SERVICE INFORMATION BULLETIN

NUMBER: 18-231-23
DATE: 09/11/23

SUBJECT: Service Manual Correction for EyeSight® Adjustment/Calibration Error Codes 1403-1407

Specified Vehicle Tolerance Tilt Range:

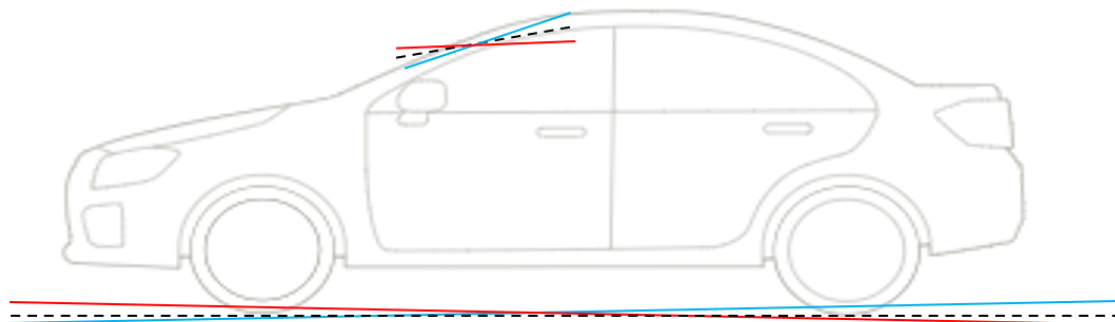
**13. The Tolerance Tilt (deg) MUST be within the specified range.
See Below**

Blue Line indicates Forward Tolerance Tilt
 Red Line indicates Backward Tolerance Tilt

Model	MY	Tolerance Tilt [deg]			
		Vehicle (Rocker Panel)		EyeSight® Plate	
		Forward	Backward	Forward	Backward
Outback	15-19	0.71	-0.29	17.6	14.4
	20-22	0.71	-0.29		
Legacy	15-19	0.5	-0.5		
	20-22	0.5	-0.5		
Impreza SDN	15-16	0.52	-0.52		
	17-23	0.52	-0.52		
Impreza WGN	15-16	0.52	-0.52		
	17-23	0.52	-0.52		
Crosstrek	15-17	0.74	-0.3		
	18-23	0.73	-0.3		
Forester	17-18	0.74	-0.3		
	19-21	0.73	-0.3		
WRX/STI	16-21	0.52	-0.52		
Ascent	19-22	0.81	-0.14		
BRZ	22-23	0.53	-0.53

Vehicle (Rocker Panel) Tolerance Tilt Measurement Procedure:

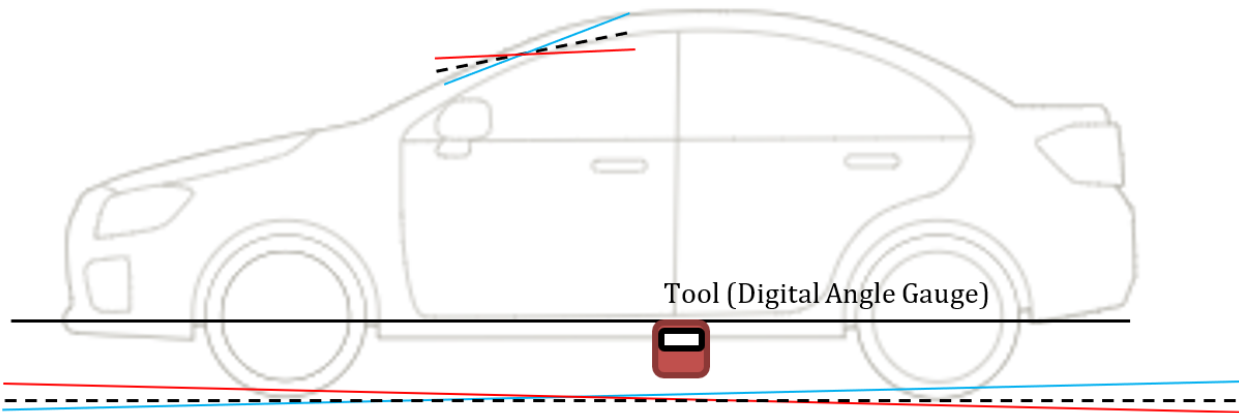
1. Perform a zero adjustment of the digital angle gauge at the left lower end flange side of the rocker panel. See the images below.
2. Measure the angle of the left center area of the rocker panel and record the reading.
3. Perform a zero adjustment of the digital angle gauge at the right lower end flange side of the rocker panel. See the images below.
4. Measure the angle of the right center area of the rocker panel and record the reading.

NOTE: Be sure to measure near the center of the side rocker panel and **NOT** on the jack positions.

EyeSight® Plate Tolerance Tilt Measurement Procedure:

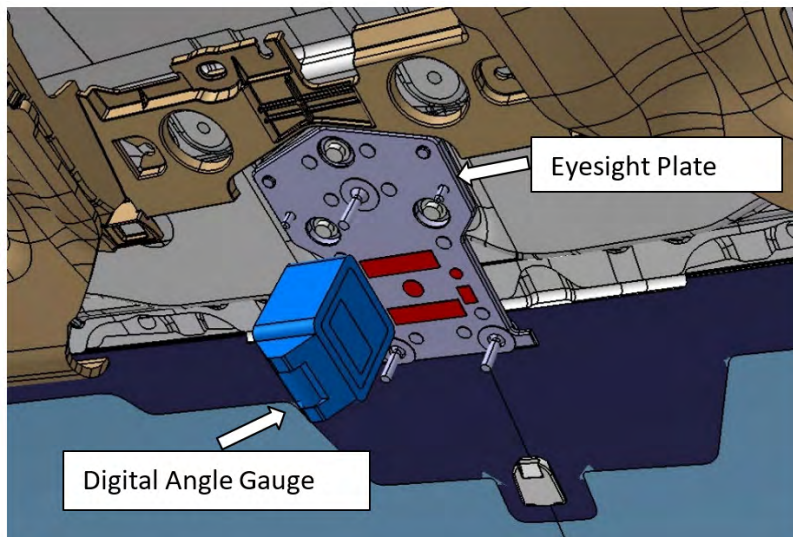
Measure the angle of the plate/stereo camera mount.

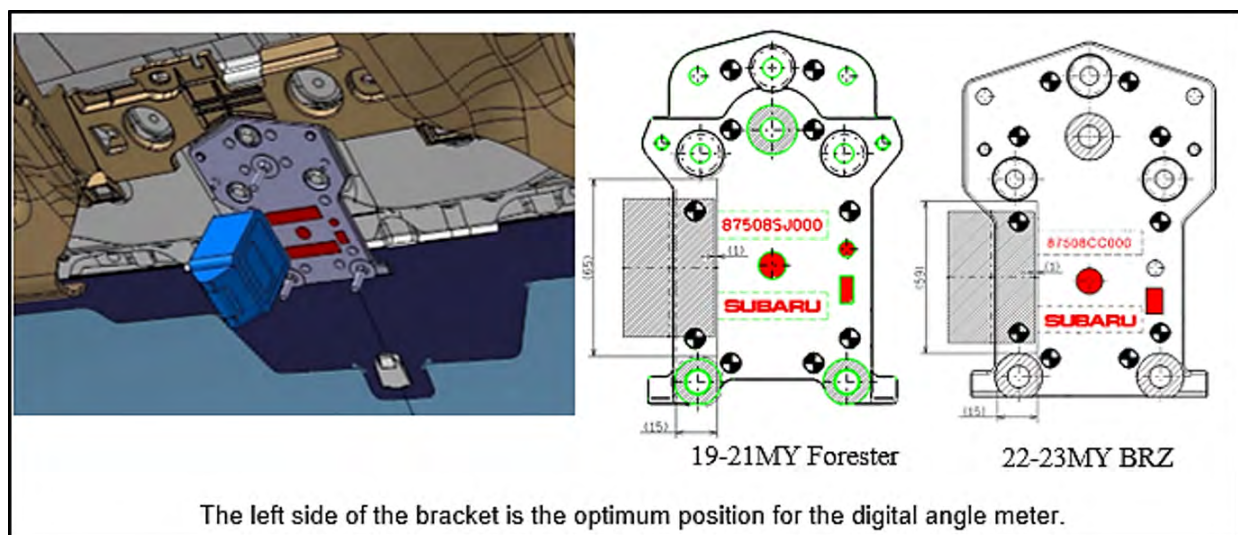
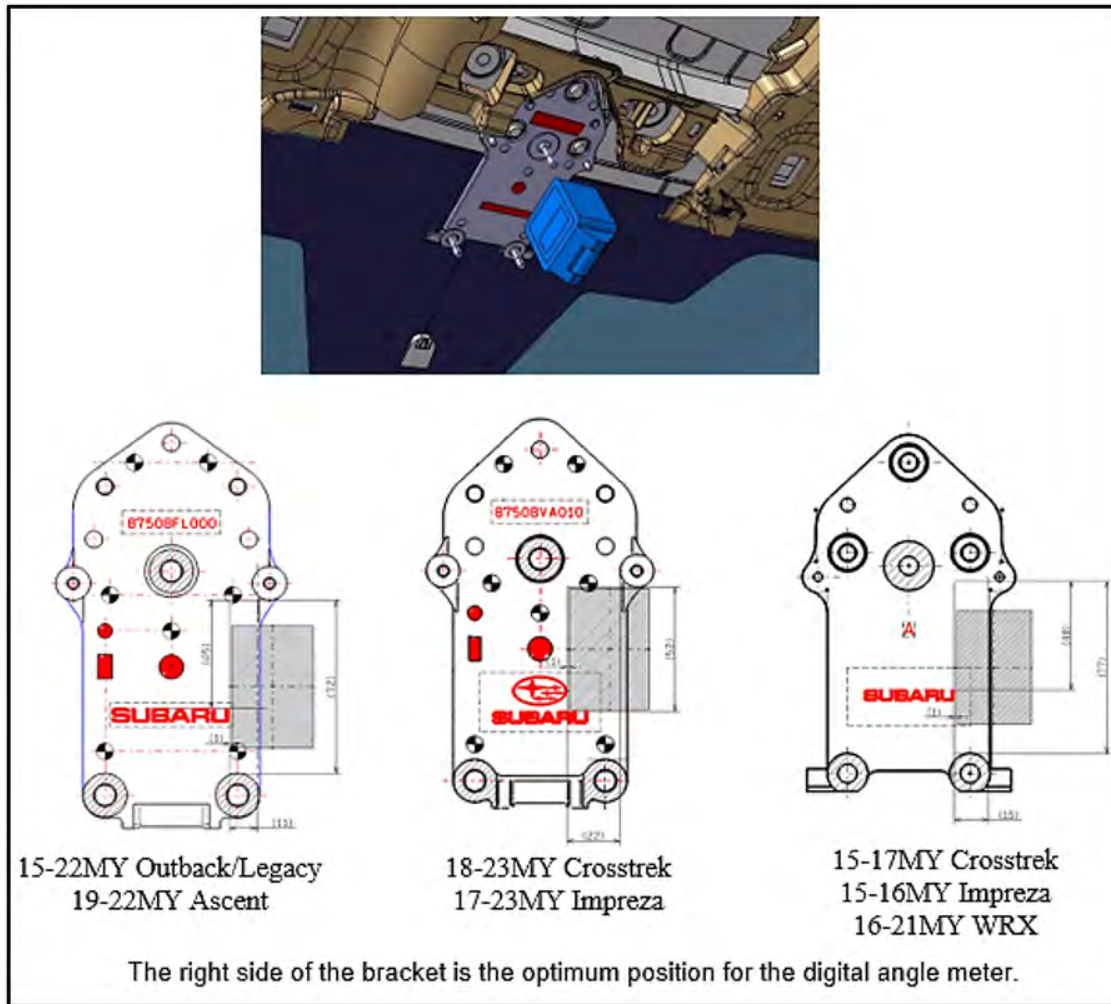
Install the angle gauge onto the section of the plate/stereo camera mount without any protrusions. This will provide the most accurate measurement.
